ORIGINATION FORM

Proposed Revisions to a Standard Plans Index
(Please provide all information — Incomplete forms will be returned)

Index Number: 700-040
Sheet Number (s): 2 of 5
Index Title: Cantilever Sign Structure

FOOTING AND PEDESTAL

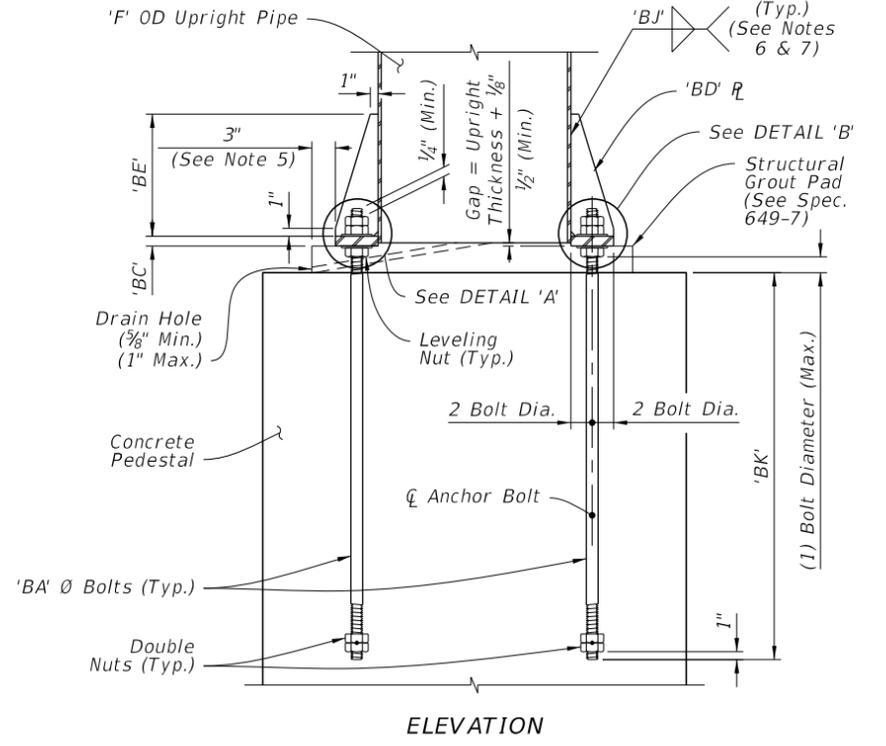
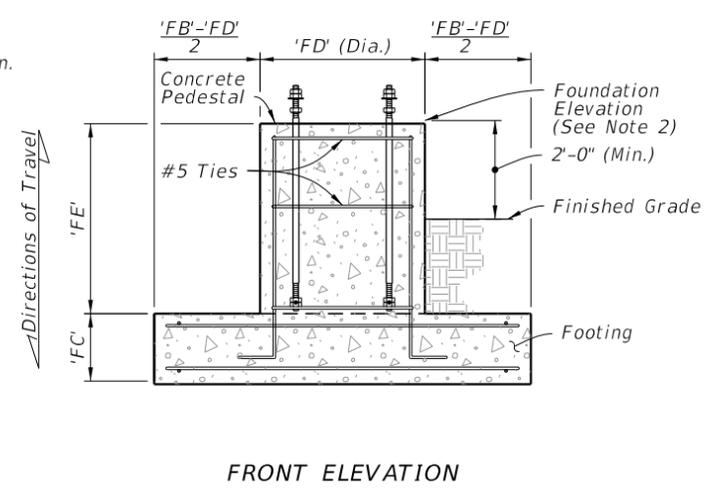
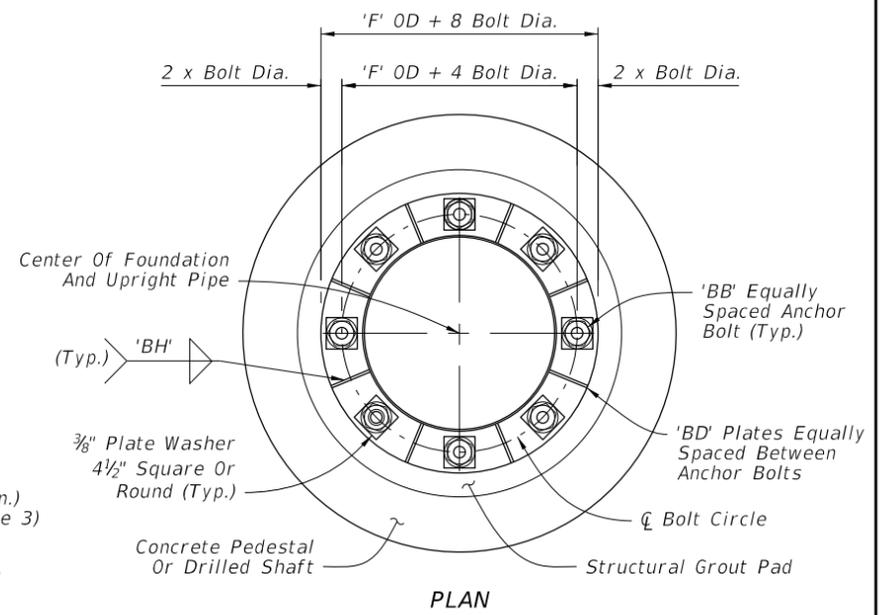
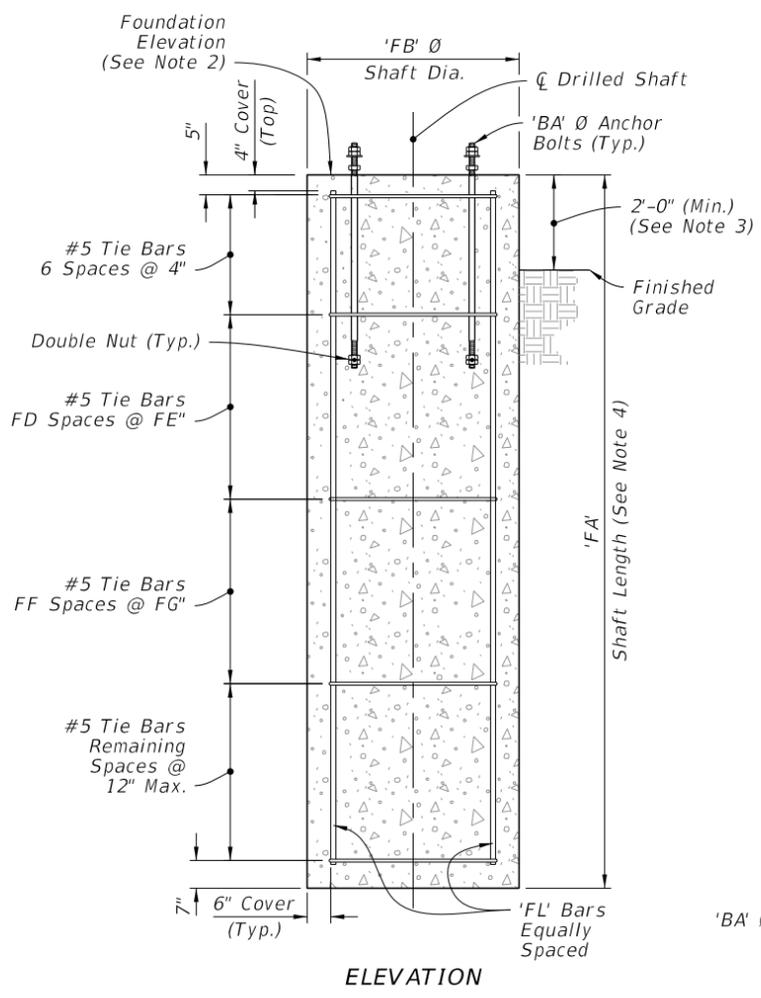
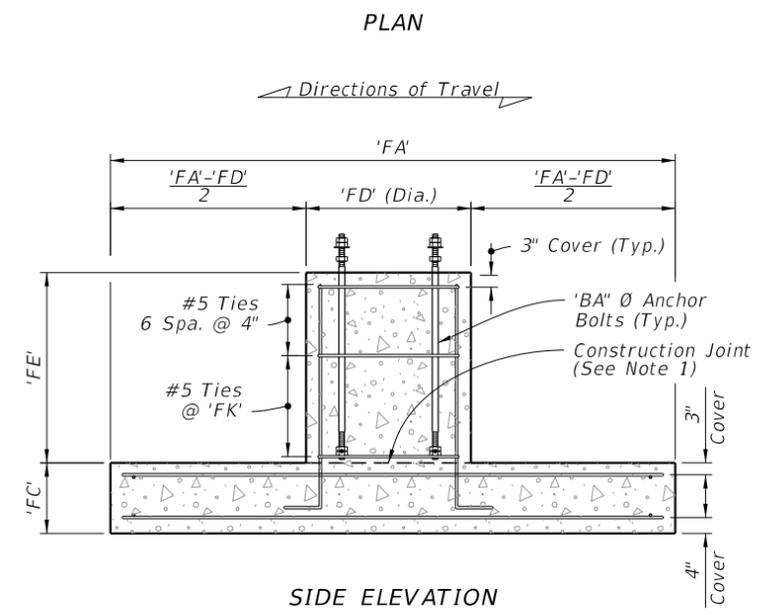
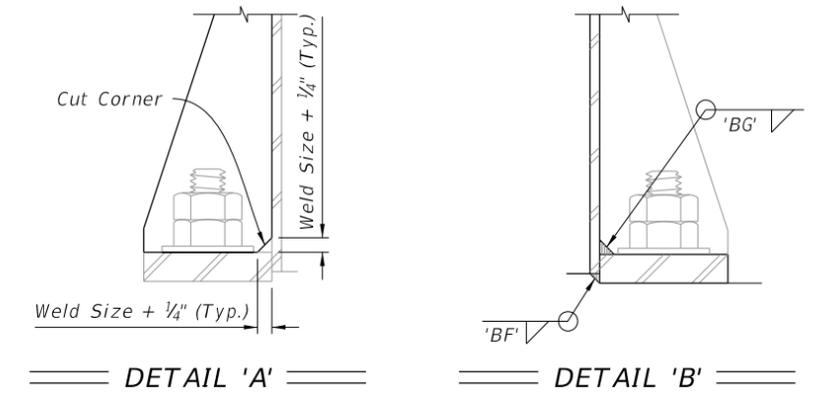
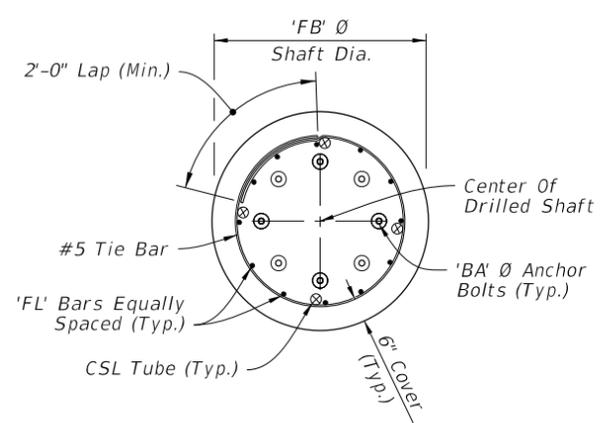
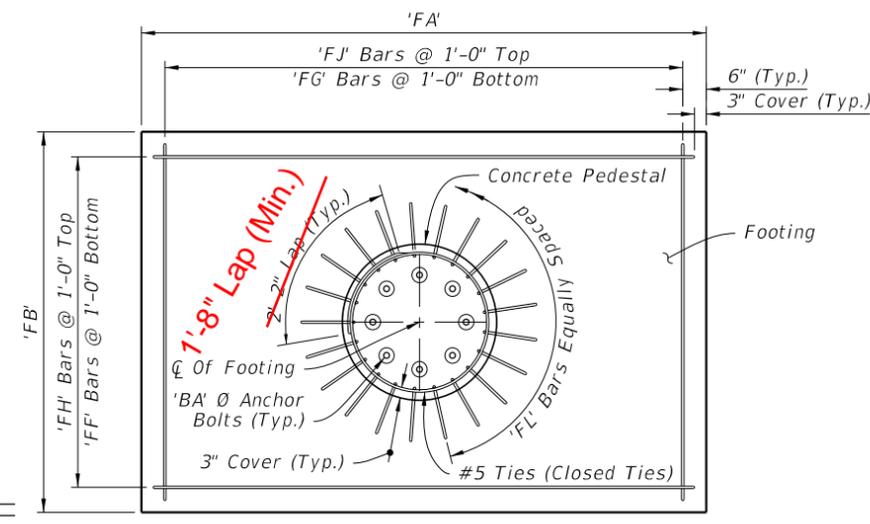
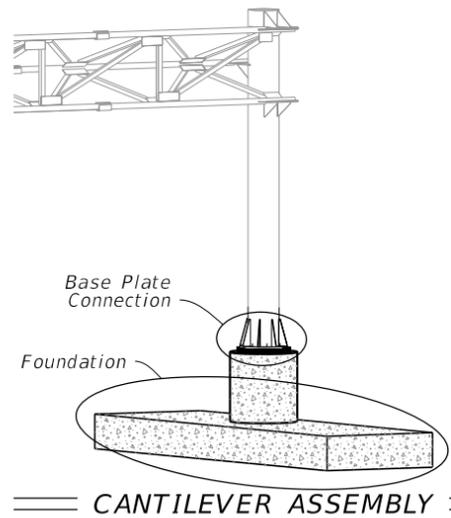
Sheet 2: Changed the 2'-2" lap splice for the #5 tie bars on the spread footing plan view to 1'-8"; Revised Note 5 to read "After galvanizing, provide magnetic particle testing on 100% of upright fillet welds."

Additional Commentary: During maintenance inspections, weld cracks were found on in-service overhead sign structure supports. A FDOT investigation determined the cracks were formed during fabrication. To implement a better fabrication quality control processes, the note on the Standard is being changed.

The reference shown for longitudinal bars is incorrect.

Required lap length for #5 tie bars for spread footing shall be shorter rather than longer than what is required for drilled shaft (2'-0") due to higher concrete strength of spread footing.

- NOTES:**
- Construction joint allowed, roughen surface to 1/4" minimum amplitude prior to pour.
 - See Traffic Plans for elevation at top of Foundation.
 - Install Drilled Shaft with a 2'-0" minimum from top elevation of the drilled shaft to the finished grade, unless specified otherwise in the plans.
 - The shaft length is based on 2'-0" height above finished grade.
 - Structural Grout Pad dimension may be modified to be less than 3" where the footprint of the Structural Grout Pad does not provide adequate clearance for accessibility considerations.
 - Wrap fillet weld around the stiffener termination on the tube wall.
 - Provide ultrasonic testing for Lamellar Tearing when wall thickness exceeds 1/2"
- After galvanizing, provide magnetic particle testing on 100% of upright fillet welds.**
